IREDELL COUNTY HEALTH DEPARTMENT

IMPROVEMENT PERMIT / AUTHORIZATION TO CONSTRUCT / OPERATION PERMIT / EXISTING SYSTEM INSPECTION

PERMIT# 1196 38 PIN# 4625505104.435 4626-28-5785 DATE 6-9-06

SUBDIVISION The Farms BLOCK / SECTION 3 LOT 435 LOT AREA 1 Acre SITE CLASS. PS DESIGN FLOW 600gpd T.A.R. .3

AS BUILT SKETCH

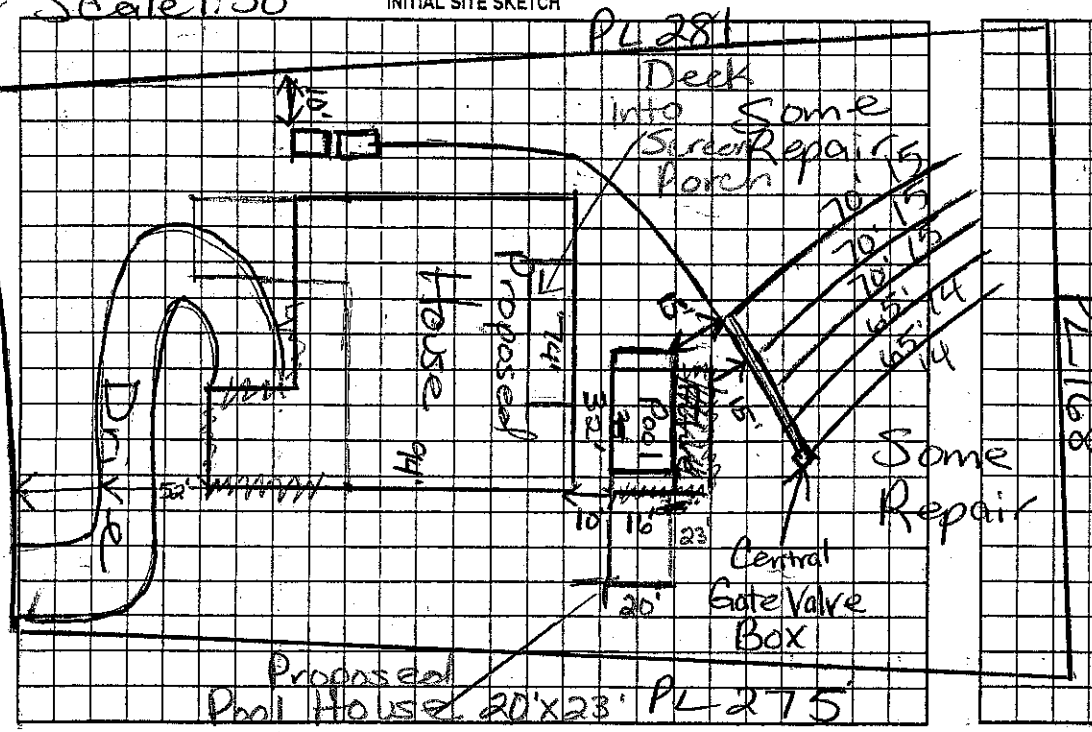
Comments:/Conditions: Must keep Future pool 15ft from Septic System & 10ft from Supply line. Checked tanks & lines 3/11/06

The proposed / existing Pool House & Screen Hse. addition does not appear to impact the existing septic system.

**NOTE: Must keep any Building 5ft from Septic

The location of the proposed Pool addition does not appear to impact the existing septic system.
